RE: Certificate of Appropriateness Application
BAR 16-11-01
401 Cherry Avenue
Tax Parcel 290150000
KHM Hotels, DJ Meagher, Owner/Purcell Construction, Andrew Purcell, Applicant
Proposed changes to materials for retaining wall

**CITY OF CHARLOTTESVILLE
BOARD OF ARCHITECTURAL REVIEW
STAFF REPORT
November 15, 2016**

BAR 16-11-01

Proposed changes to materials for retaining wall

UNILOCK - PLANK PAVERS (MODERN) - COLOR UMBRIANO

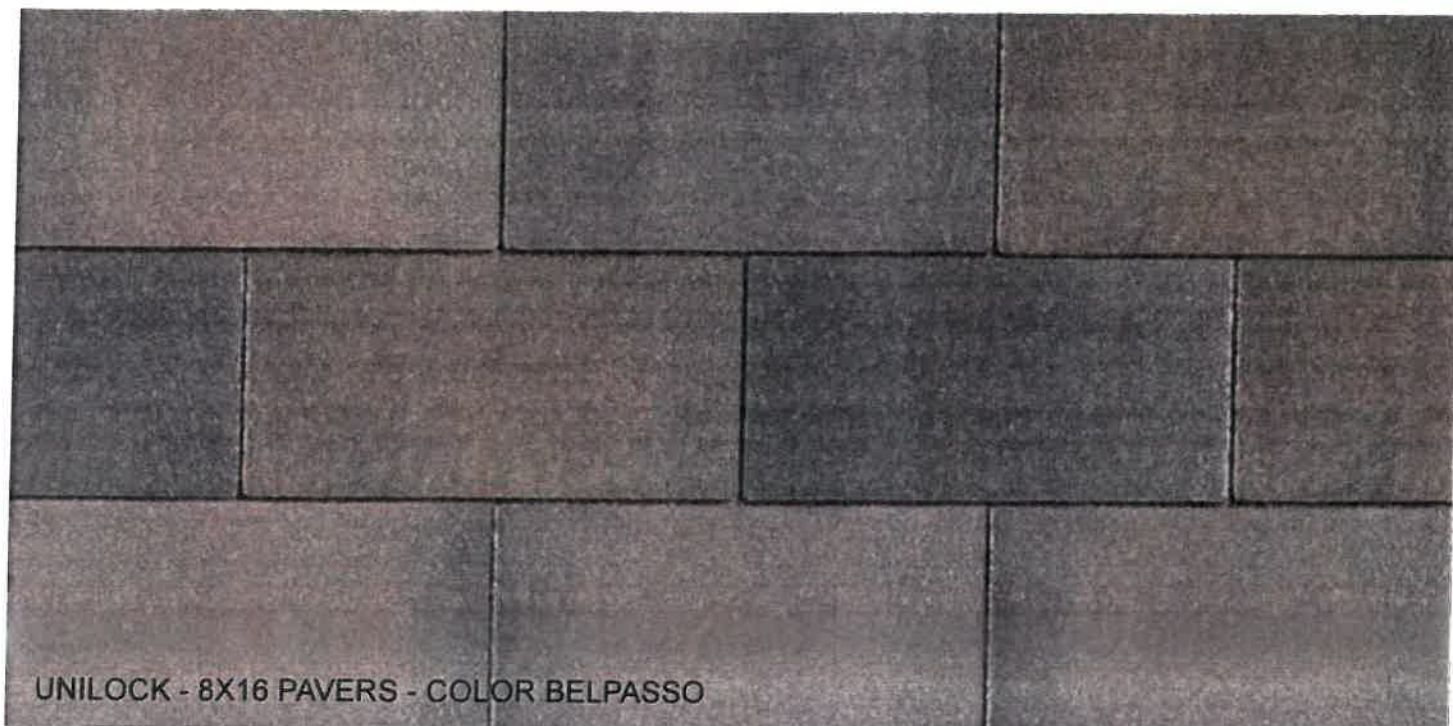
- *Change Request #3 – Provide stamped concrete in lieu of pavers @ corner plaza and building entrances*
 - We would like to have the durability of concrete yet with the same appearance and look as provided by the pavers. Pouring these as stamped concrete slabs will eliminate any differential heaving or settlement that can occur with pavers, and provides a more maintenance free surface. The pattern, texture, and color of the stamped concrete will match the approved paver appearance.

3. We propose to supersede the brick pavers at the recessed planters and community plaza area with stamped or brush finished concrete. We believe this will give the high traffic areas a more durable and long lasting finish while maintaining the aesthetic value.

1. In staff opinion, the proposed retaining wall may have an advantage of having a more vertical angle, but the appearance of the larger scored blocks is not as attractive. The justification for the replacement material is that the original block does not lend itself to taller installations, however, photos of the original wall material show a very tall installation.
2. Staff does not know how to address this request and #4 other than to discuss with an OSHA representative to determine if there are any other options. As approved there were 11 awnings along Cherry Avenue, and two on Ridge.
3. Staff cannot recommend this change in paving material.

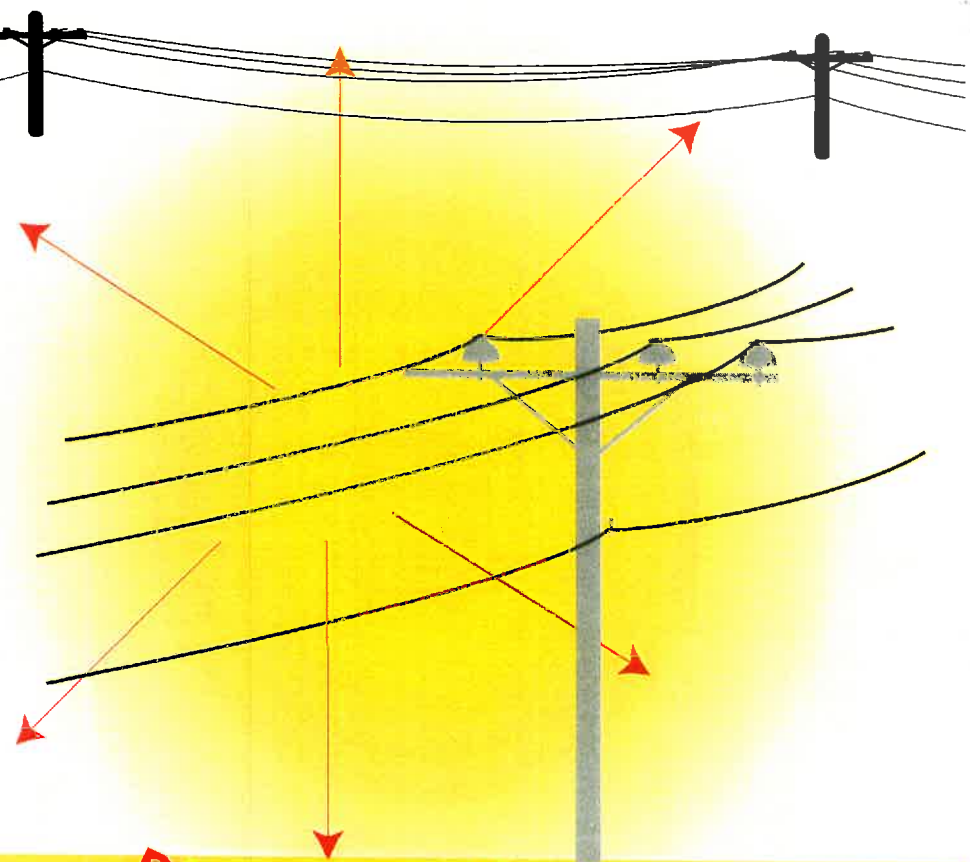
- *Change Request #2 – Eliminate the fabric awnings from the upper portion of the façades*
 - For reasons mentioned in change request #4: the awnings encroach the safe limit line of the adjacent power lines.

2. We propose to eliminate the awnings on the 3rd and 4th floors along Cherry Ave due to the proximity of the overhead power lines. Per OSHA "Safety and Health Regulations for Construction", sections "CC 1926.1408(a)(2)(ii)" (attached), we cannot work within 20' of the power lines. As the attached drawings show, we are well within that limit. In addition to the safety of our employees, we also would like to refrain from moving the lines so that we do not affect the power supply to the local community.

Subject: WTP pole/line survey

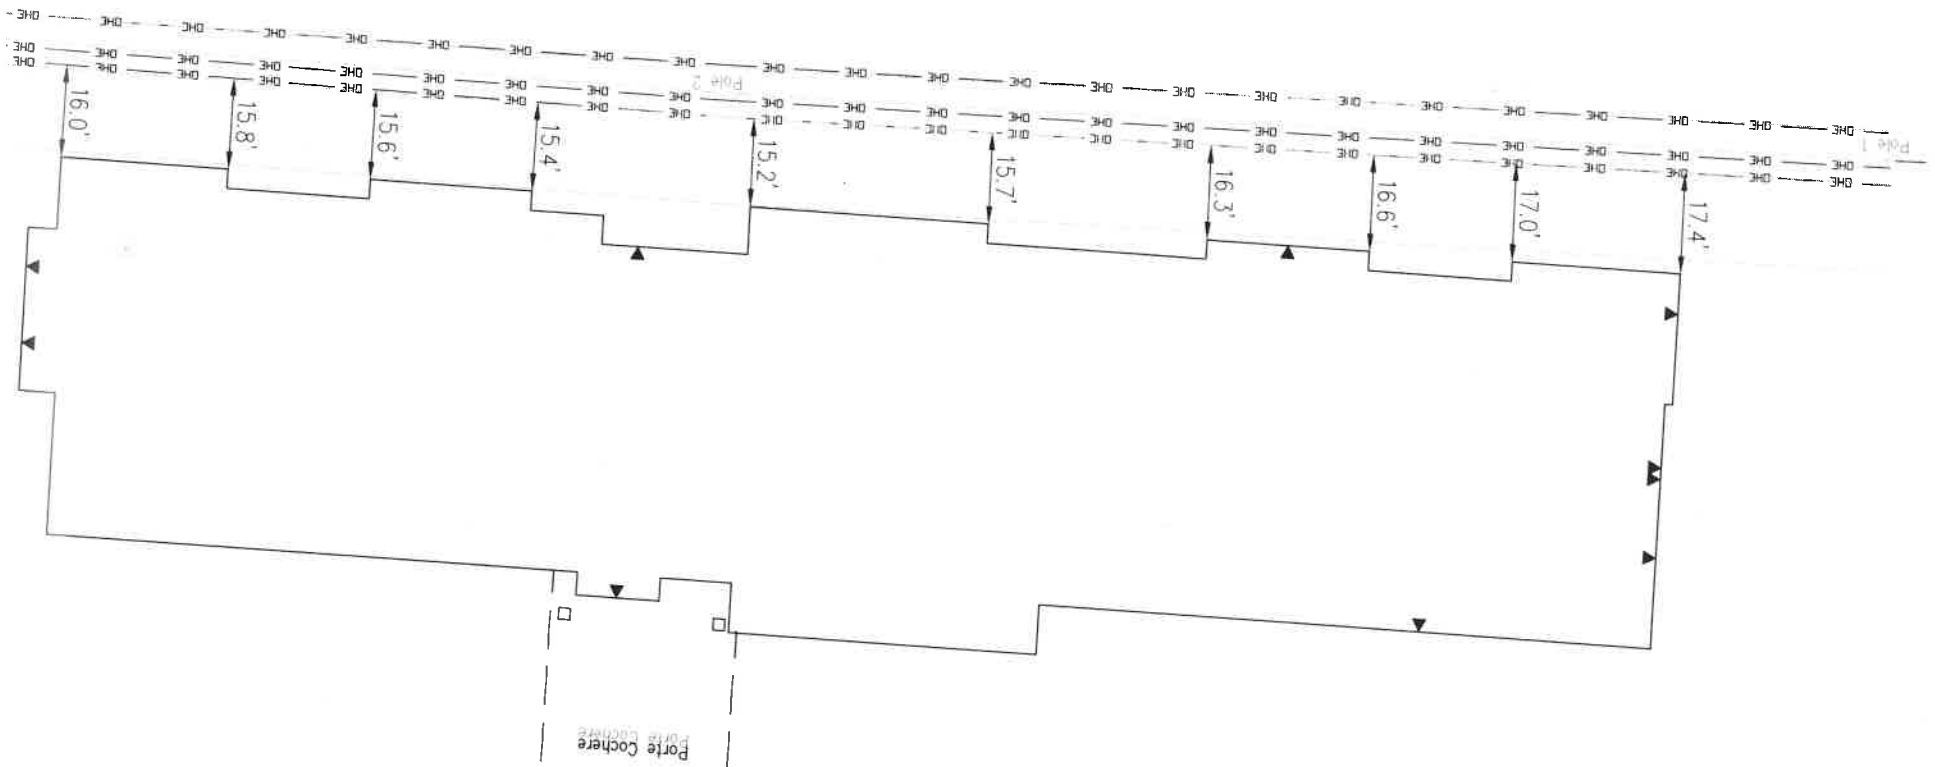
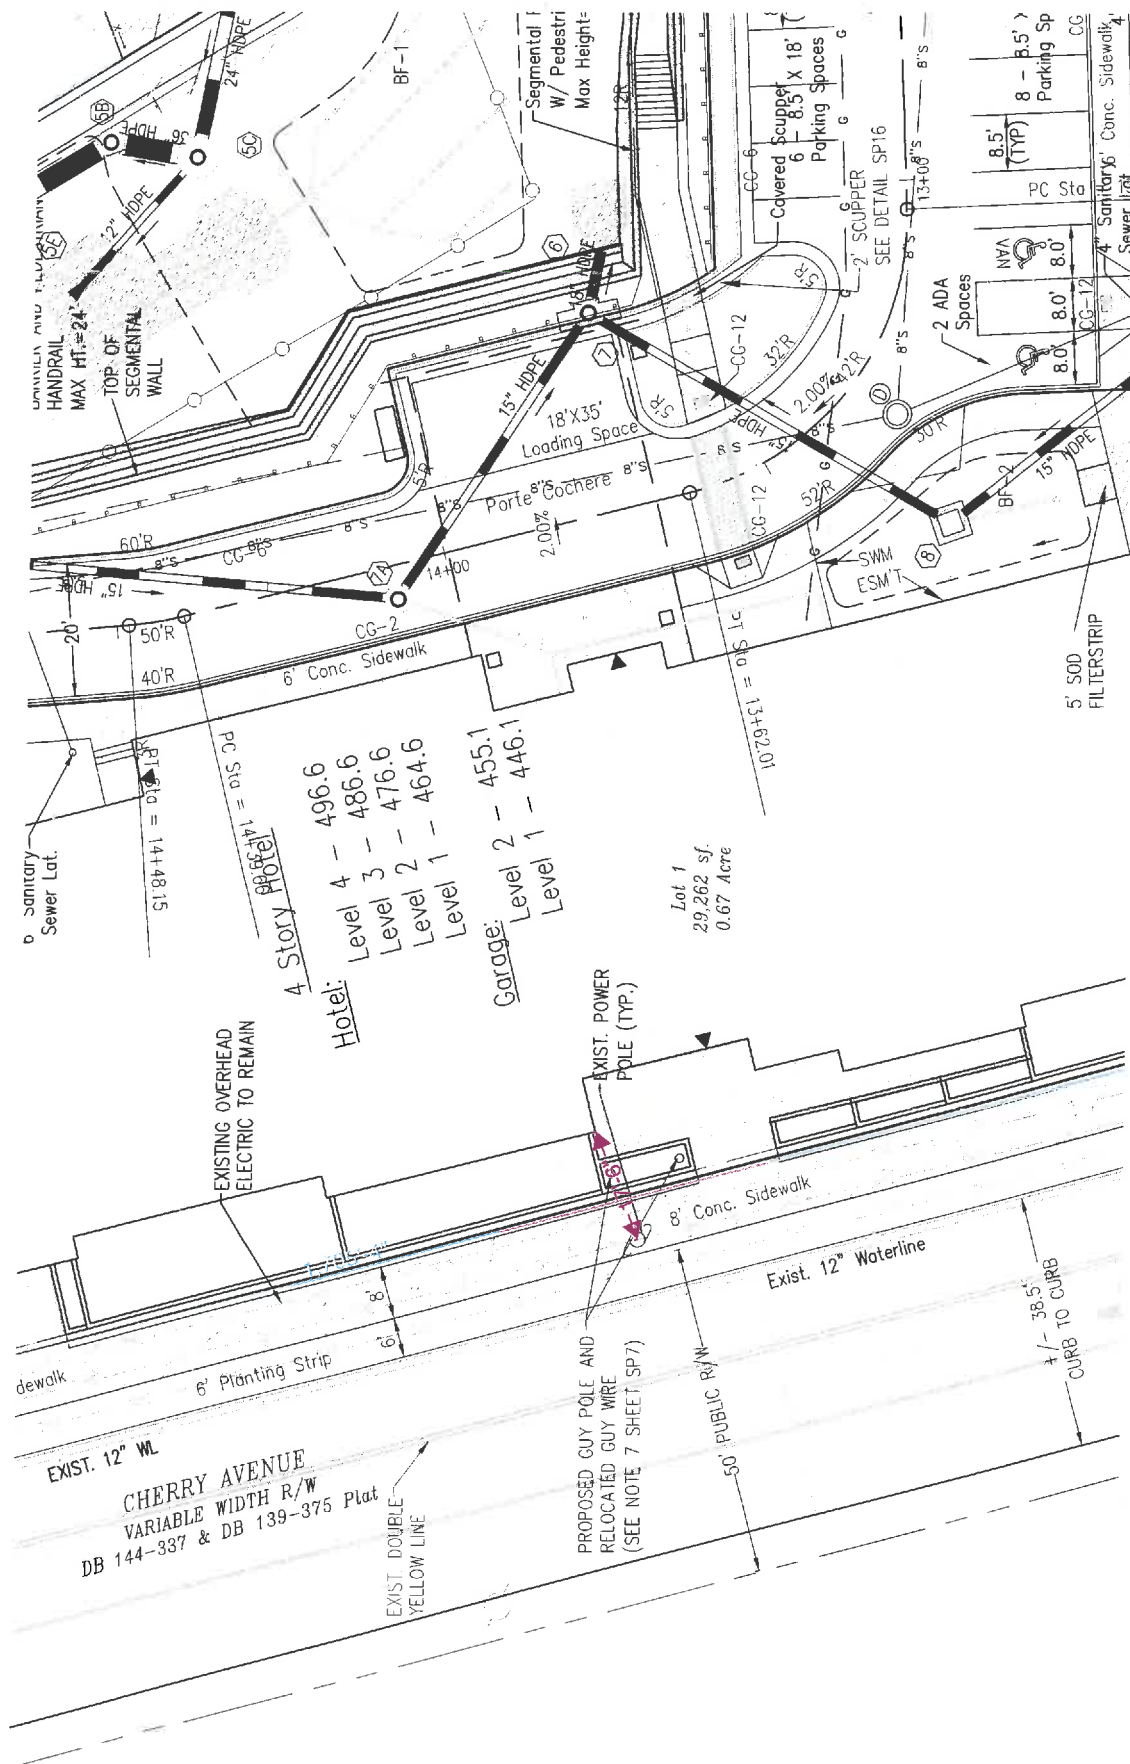
Gents, we re-surveyed the 230kV overhead lines on Cherry yesterday, and the result was very close to what was shown on the approved site plan. See attached detailed plan with dimensions to building and pole schematic detail. In the schematic detail, the pole location is where we surveyed the pole at ground level. As you can see, there is some lean and kinks in the poles themselves. Also see attached pic of Pole 2 top. Let's discuss at 3:30, thanks! Mike

1. SOUTHWEST ELEVATION

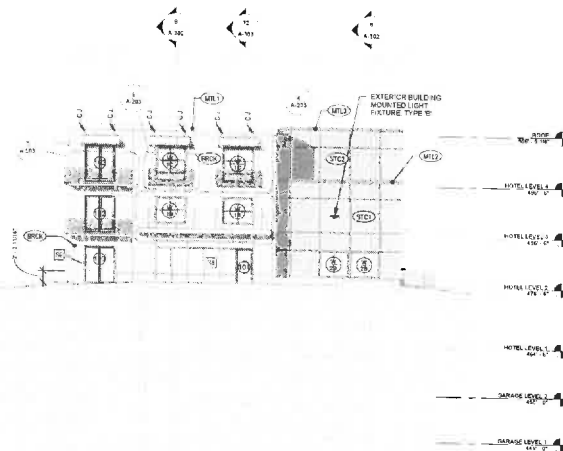
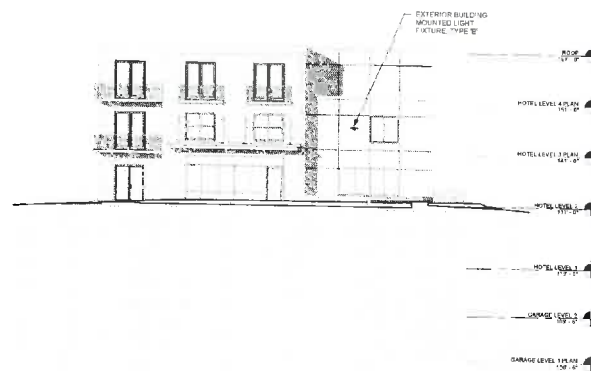
- *Change Request #4 – Portions of brick veneer to become stucco, painted color pennywise (previously approved for stucco at parking garage)*
 - While working with the GC, Purcell Construction, it has become apparent that the powerlines running adjacent to Cherry Avenue create a safety concern during construction. Installing the brick veneer requires ample scaffolding and staging of material. Providing this scaffolding and staging would encroach the safe limit line of these power lines. If we change the brick veneer at these portions to stucco, it eliminates the need for this type of scaffolding, and thus alleviates the safety concern. We are proposing to change portions of the brick veneer to stucco, with horizontal v-joints at 2' on center. The stucco

4. We propose to change portions of the brick veneer to a painted stucco. Please see architects explanation and rendering.

4. Staff has requested a color drawing so the proposed change from brick to stucco. Again, Staff does not know how to address this request and #2 other than to discuss with an OSHA representative to determine if there are any other options. Staff does not understand why stucco can be safely installed, but not brick.
5. In staff opinion stucco is more appropriate. The rear elevation is very visible.

1 NORTHEAST ELEVATION
SCALE 3/32" = 1'-0"

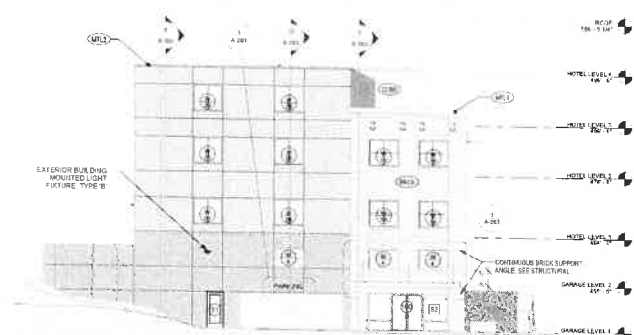
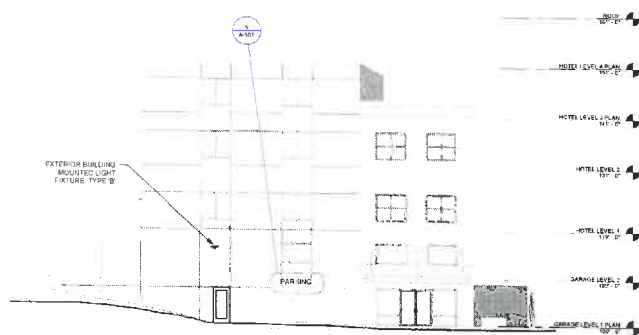
- *Change Request #5 – Portions of stucco at Northeast Elevation (rear façade) to become clapboard, painted the same color as the approved stucco*
 - The original approved design was to break up the building as much as possible through the use of building mass and material. We feel this concept was successfully implemented on the Cherry Avenue and Ridge Street facades, but could be executed better on the back façade of the building. Our proposal is to replace portions of the stucco with clapboard, as to break up the long stucco façade that was approved. The clapboard will be painted the same color as the approved stucco in these locations. See building elevations for locations.

5. We propose to change portions of the stucco at the northeast elevation (rear Façade) to painted clapboard. Please see architects explanation and rendering.
